Update to the SAF Two-Side Axle Lift for INTRA Series With Aluminium Hanger Brackets

Part: **03 027 1244 01**

to be replaced by: **03 027 1280 01**

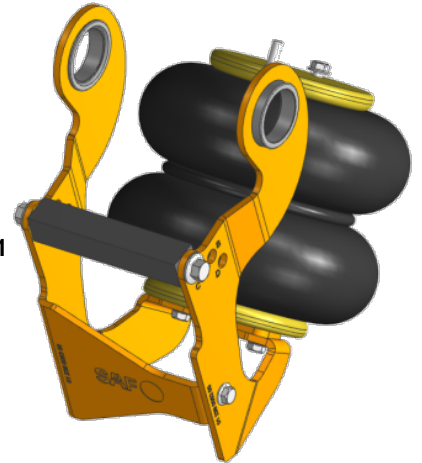
Now that the two-side lift for steel hanger brackets has been updated, the version for aluminium hanger brackets is also to be adapted to make its installation much easier.

- No dismantling of the spring bearing during installation
- No need to change to the longer spring bearing screw
- Reduction in the time needed for installation thanks to hinged side part.

- This means it has been possible to reduce the weight per axle by 3 kg to 22 kg.
- Highly corrosion resistant thanks to cathodic electrodeposition (CED) coating (504h salt-spray testing).
- The lift arms can be painted over.

Picture shows 03 027 1280 01 – “unfolded”

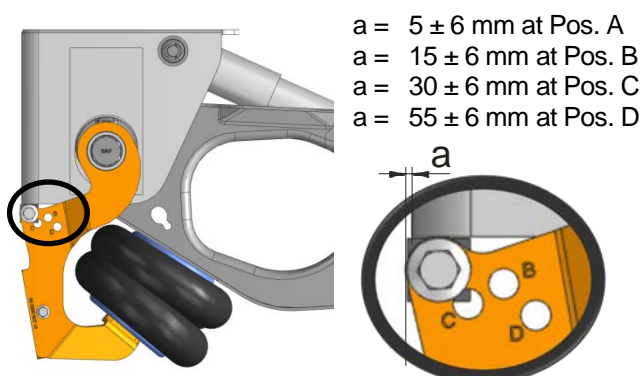
The lift arm has several possible support positions. You will find details of how to align the series (combination of hanger bracket / air suspension bracket and airbag) with the support position in the installation instructions and in the [design manual](#).

It is essential to ensure the lift arm extends the correct distance (a) beyond the hanger bracket depending on the support position:
